# City of Newton, Massachusetts

## PUBLIC HEARING MEMORANDUM

**SUBJECT:** **Petition #311-23** for SPECIAL PERMIT/SITE PLAN APPROVAL to demolish the existing dwelling and construct four single-family attached dwellings with dimensional waivers, and to allow a driveway and parking within setback distances at **2202 Commonwealth Avenue**, Ward 4, Auburndale, on land known as Section 41 Block 13 Lot 06, containing approximately 13,696 sq. ft. of land in a district zoned MULTI RESIDENCE 1. Ref: 7.3.3, 3.4.1, 3.2.4, 6.2.3.B.2 of Chapter 30 of the City of Newton Rev Zoning Ord, 2017.

**2202 Commonwealth Avenue**

***Proposed Elevations***

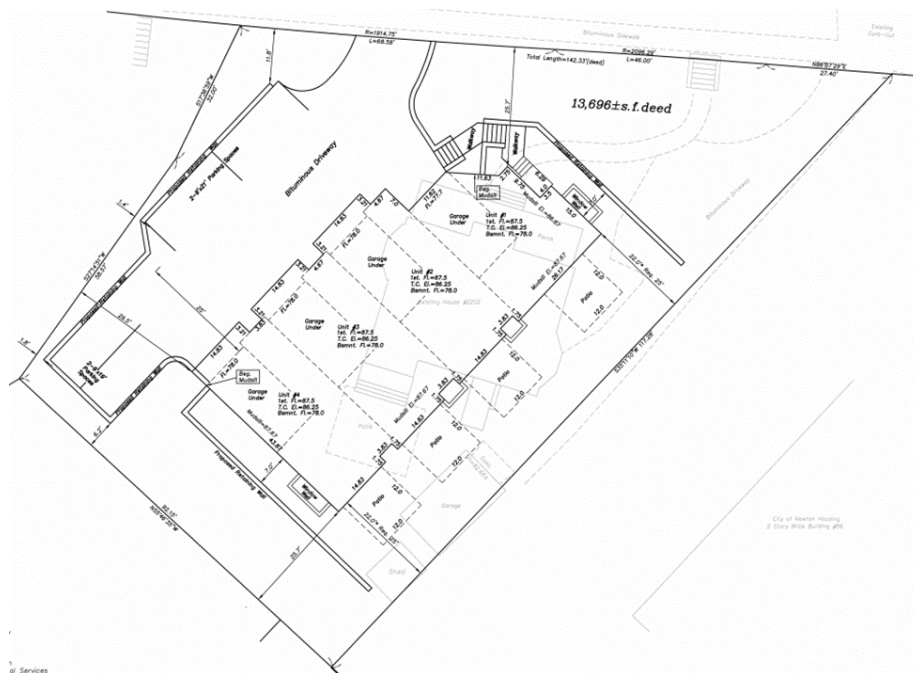
While the proposed structure's height would be four feet higher than the existing structure's conforming 31.3 feet, it is than the maximum 36 feet allowed.
